Steering Committee Meeting  
December 28, 2020 11:00am  
ZOOM

Comments and issues made during the presentation are documented in the attached document: "Items from December 28 PGPSC review of the Phase 1 - 35% Plan"

## POTRERO GATEWAY PROJECT

## Items from December 28 PGPSC review of the Phase 1 - 35% Plan

# DRAINAGE

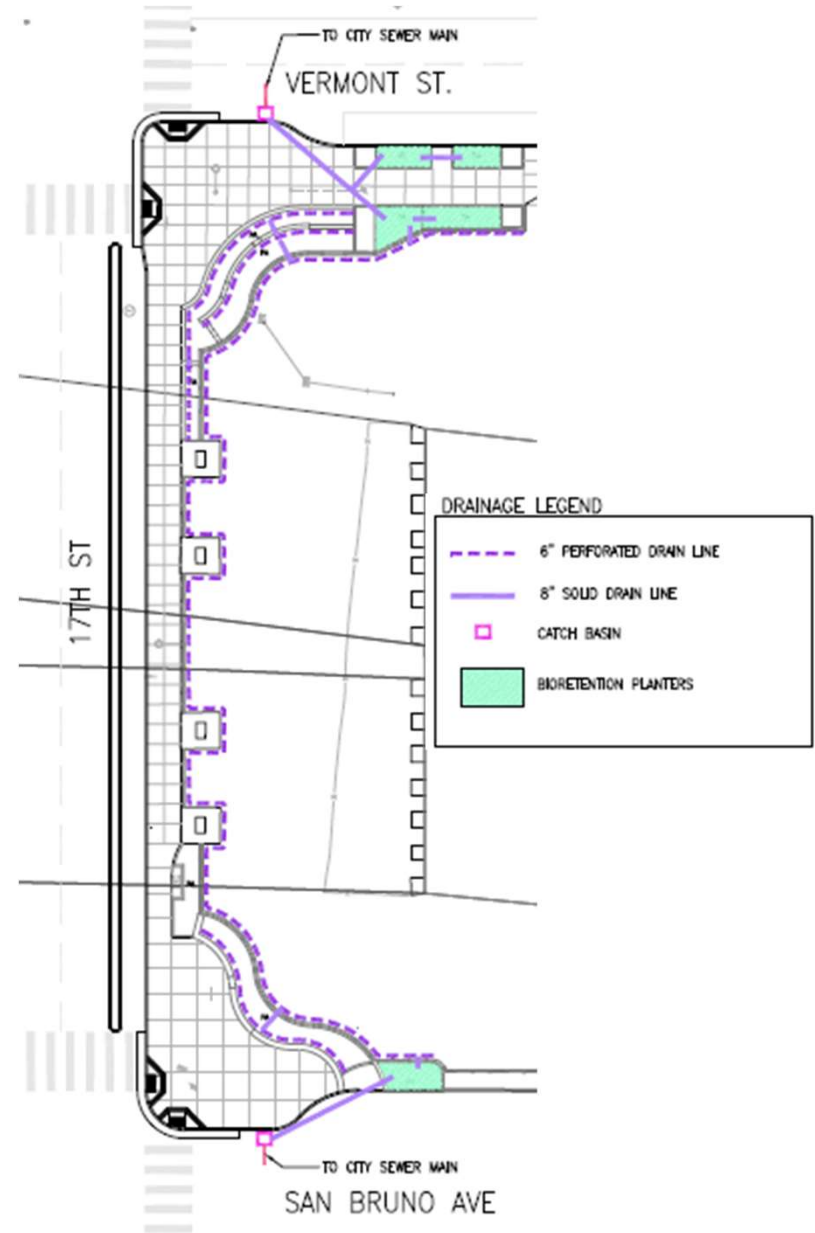
<b>17<sup>th</sup> St Hillside</b>		
	Is the drainage appropriate?	The hillside drainage is not part of an engineering design, but is there to suggest that drainage will be addressed.

# DECORATIVE CROSSWALK

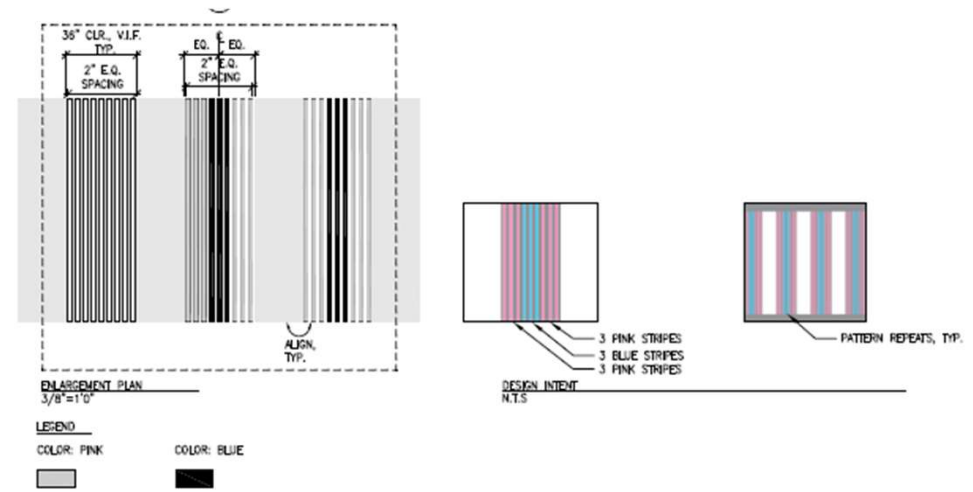
\*Crosswalk color will not be blue but decorative pattern/color possibilities available for discussion
